MEMORANDUM

DATE:	July 5, 2021	RWDI REFERENCE #: 1903881
TO:	Nicholas Wilkinson	Dexus Fund Management Limited
FROM:	Kevin Peddie	[REDACTED]
	Michael Pieterse	[REDACTED]
RE:	60 Collins Street, Melbourne Request for Further Information

Image 1: Wind Comfort and Safety Limit Conditions for Level 9, 18 and 37 Terrace Areas

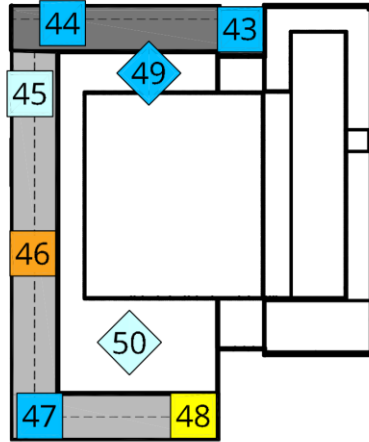
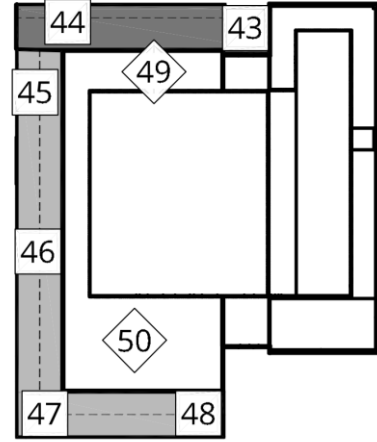
4. *Amended pedestrian wind study to include consideration of the wind conditions at level 37.*

The wind tunnel study for the pedestrian wind environment conditions previously undertaken by RWDI measured the wind speeds at the surrounding ground level areas as well as the terrace levels. This included Level 9, Level 18 and Level 37 of the development. Section 3.2 of the wind report discussed the wind conditions expected for the three terrace levels of the development. The wind conditions noted the following:

- Level 9 terrace area will satisfy the sitting comfort criteria. This is represented by sensors 43 and 44.
- Level 18 terrace will be exposed to stronger south to south-westerly wind events which are channeled along the street corridor represented by sensors 45 to 48. Recommendations are made within the report to include vertical partition screens and landscaping in planters up to 2m in height, to help break up the winds in these two locations. As an alternative, the screen around the perimeter of the Level 18 terrace has been increased in height to 2.7m which will provide suitable protection to these direct winds for this area. Any landscaping as part of the fitout will further enhance conditions.
- Level 37 roof terrace will satisfy the sitting or standing comfort criteria. This is represented by sensors 49 to 50.
- All terrace levels will satisfy the safety limit wind conditions.
